ORDINANCE NO. 2012-062

AN ORDINANCE GRANTING FINAL APPROVALS FOR HAWTHORN PLACE
OUTPATIENT SURGERY CENTER AND RELATED IMPROVEMENTS ON PROPERTY
LOCATED AT THE NORTHEAST CORNER OF CENTER DRIVE AND LAKEVIEW
PARKWAY, BEING LOTS 3, 4 & 5 IN THE VERNON SQUARE SUBDIVISION IN THE
VILLAGE OF VERNON HILLS, LAKE COUNTY

**RESPONSE TO TECHNICAL REVIEW COMMENTS #2
DATED AUGUST 20, 2012
HAWTHORN PLACE OUTPATIENT SURGERY CENTER
SEPTEMBER 13, 2012**

The pole-mounted parking lot lightings fixtures will be consistent with the existing light poles and fixtures found on Lots 6 thru 8 and the diagram provided by Camman Industries, Item No. PM77216 and dated 5/25/12.

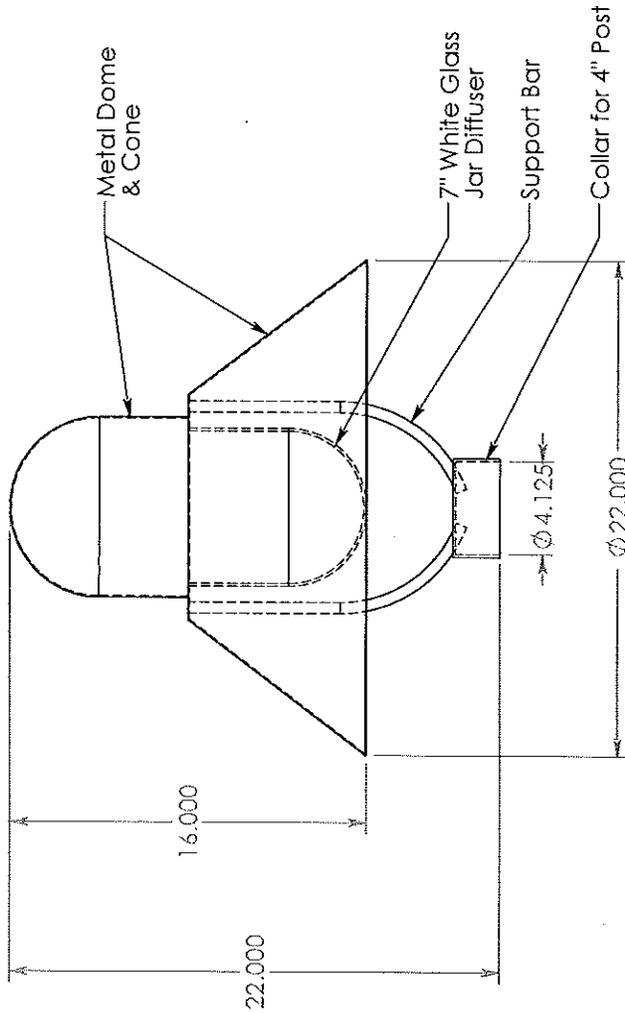
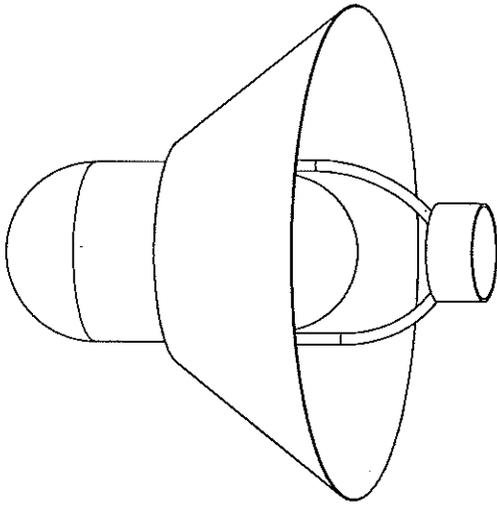
- G. The natural area maintenance plan shall be reviewed and approved by the Village Engineer prior to issuance of any site or building permit.
- H. The pole-mounted parking lot lightings fixtures will be consistent with the existing light poles and fixtures found on Lots 6 thru 8 and the diagram provided by Camman Industries, Item No. PM77216 and dated 5/25/12.

HAWTHORNE SURGERY CENTER
 VILLAGE OF VERNON HILLS
 LANDSCAPE PLAN

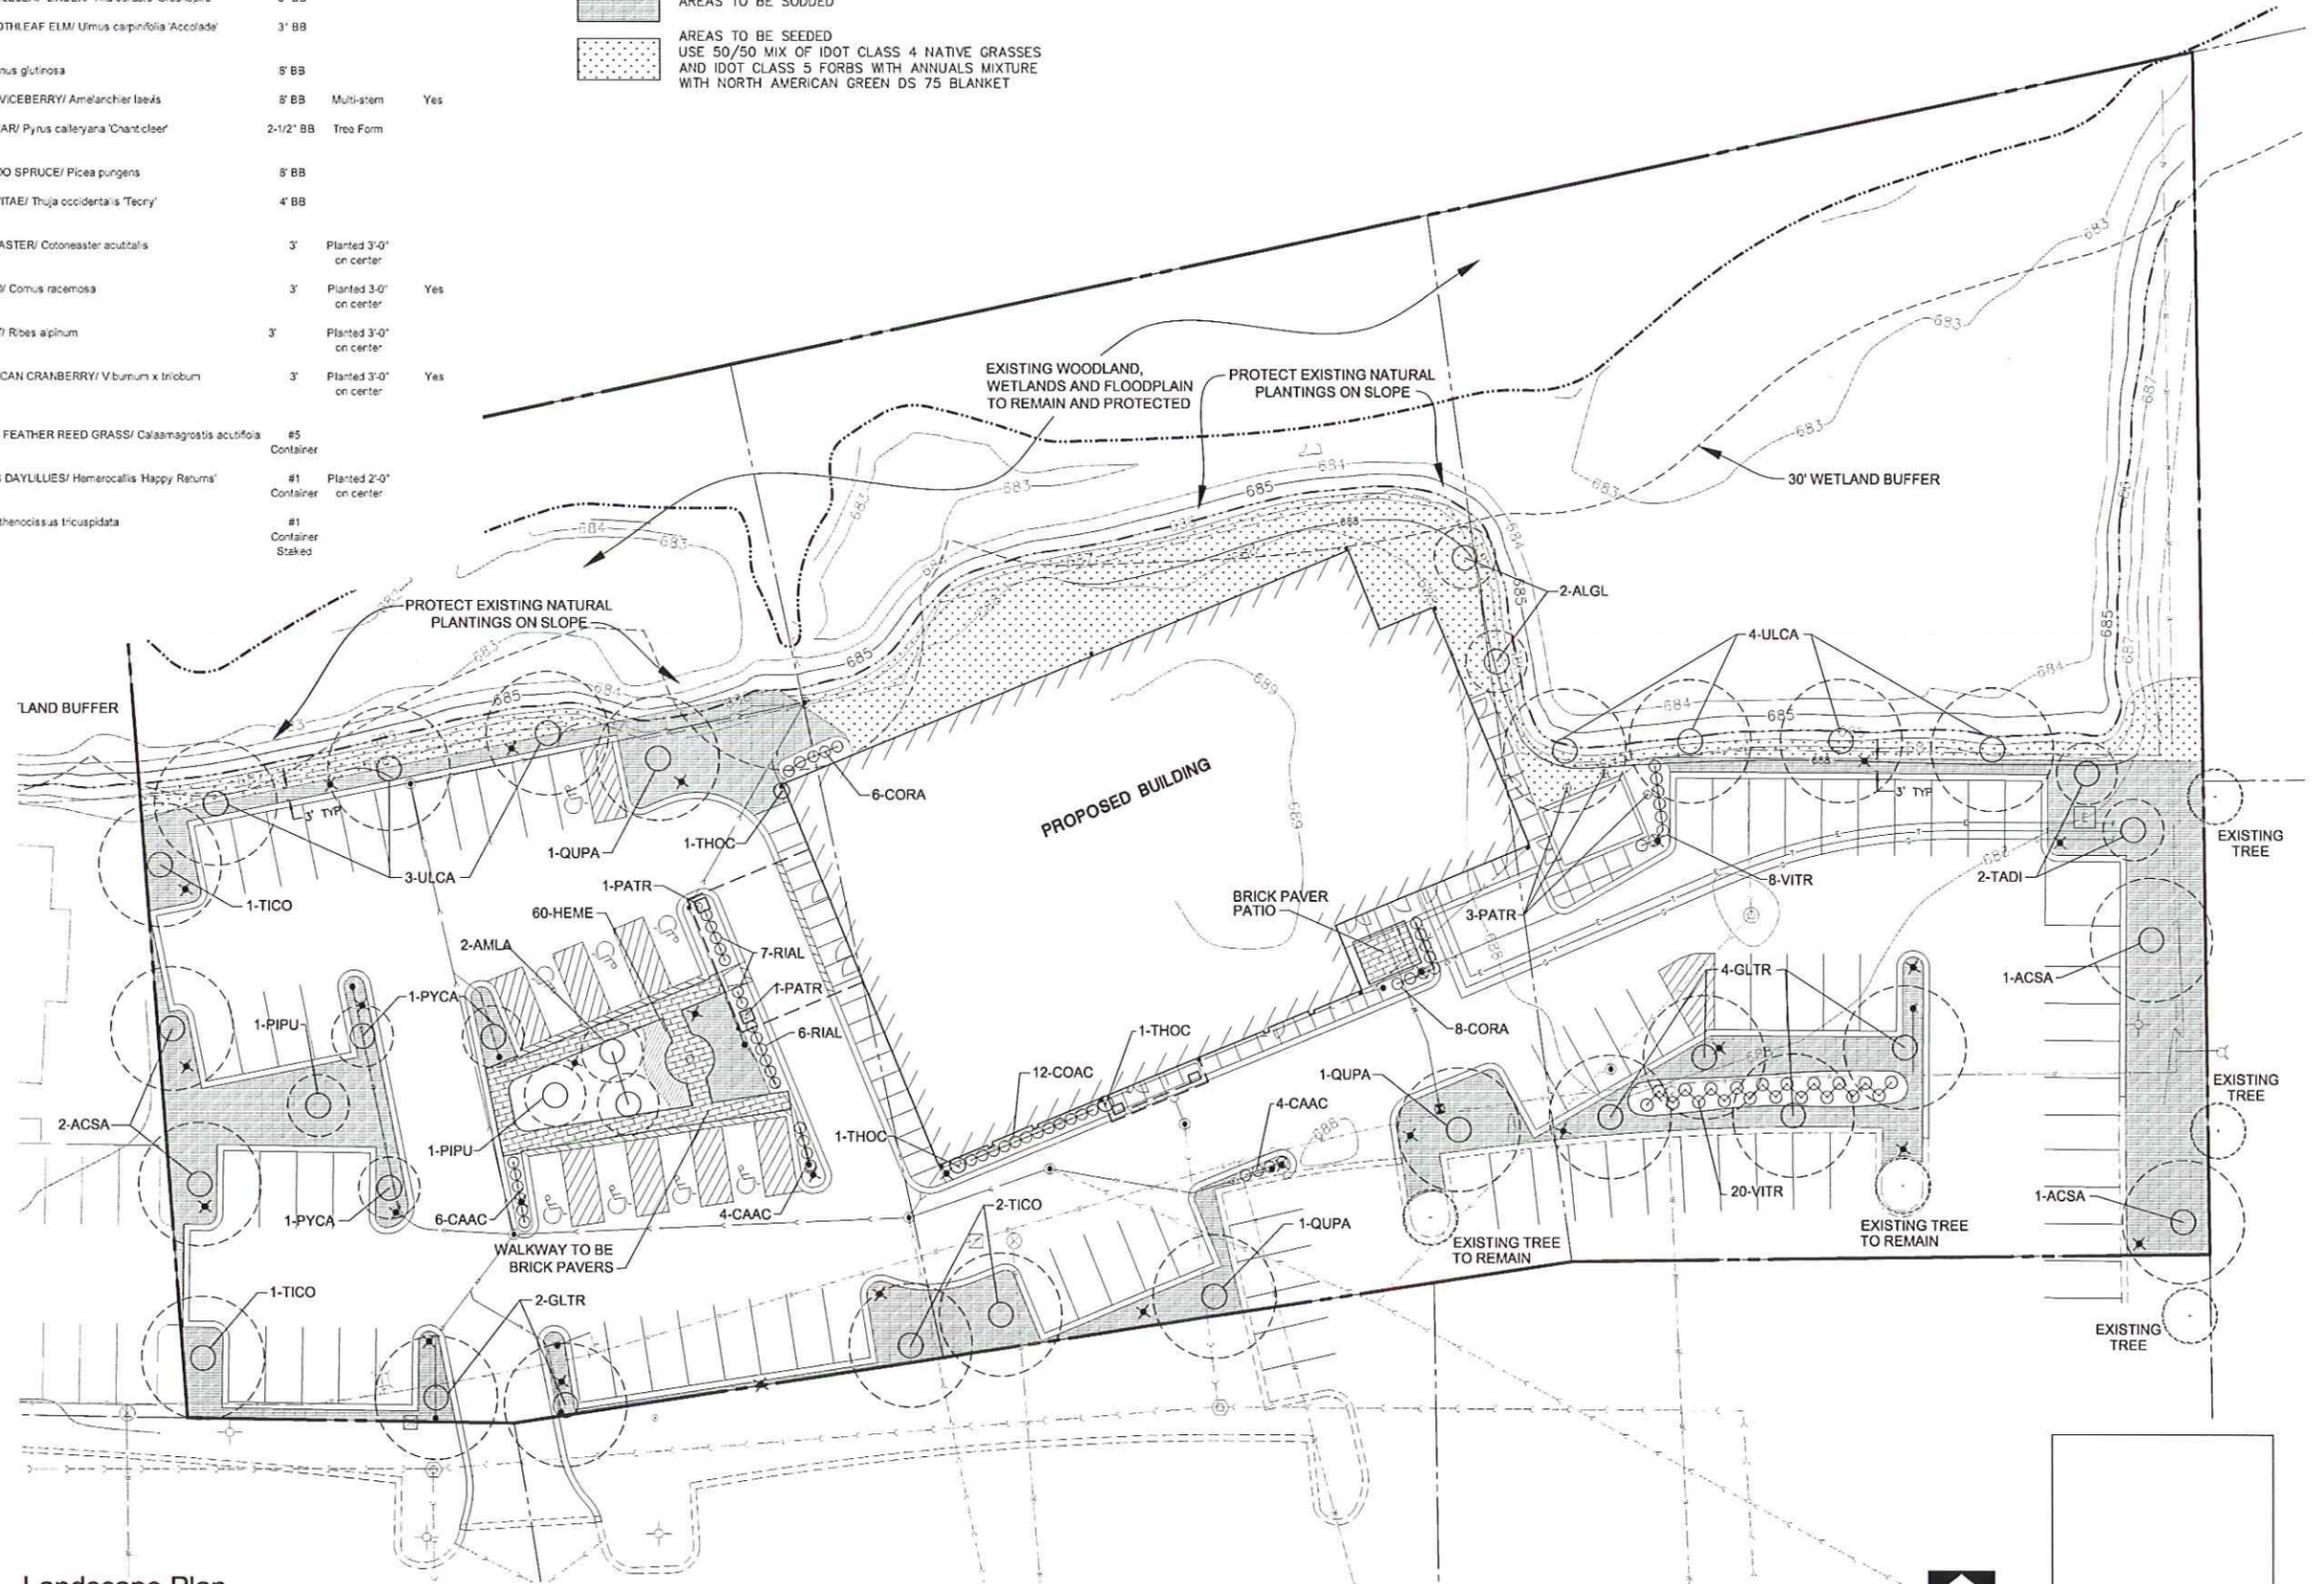
Comment 2: Include the Natural Areas Maintenance Plan in the plan set. Specify type of blanket to be used with seeding.

Response 2: We understand the Management Plan prepared by Hey and Associates will be a part of the Watershed Development Permit. Blanket has been added to the Landscape Plan Legend for Areas to be Seeded.
